STANDARD FIELD SERVICE BULLETIN

FSB Number	CHRAEFSB2016-19
Author	Tony Bryan
Date	06/14/2016
Subject	Moto G4 Plus - Touch Screen, Auto-Selects (ghost touches) w/ Turbo Charger
Model Affected	XT164x
Level Of Repairs	Level 2

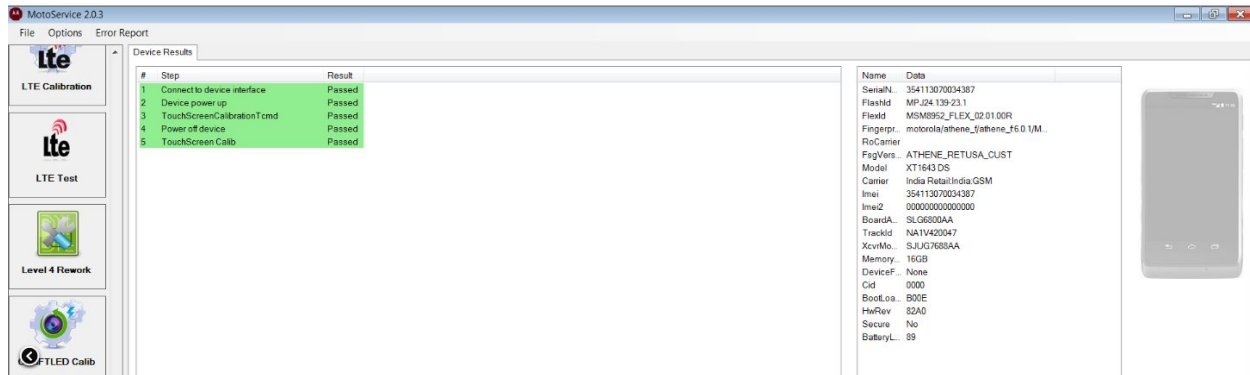
Motorola is aware of a potential customer experience issue on the Moto G4 Plus product related to touchscreen performance. Some users reported that their device would start auto-selecting (ghost touches) when connected to their Turbo Charger. Engineering analysis determined the issue was caused by incorrect calibration data from the Display/Touch panel supplier. The incorrect calibration data does not properly account for the noise level of the higher wattage Turbo Charger.

The Display/Touch panel supplier completed a screen and re-calibration of all affected material as of May 15, 2016.

A new test (TouchScreen_Cal) was integrated into the latest released version of the MotoService Tool (Version 2.0.3 and later) for Moto G4 product to complete touch panel re-calibration.
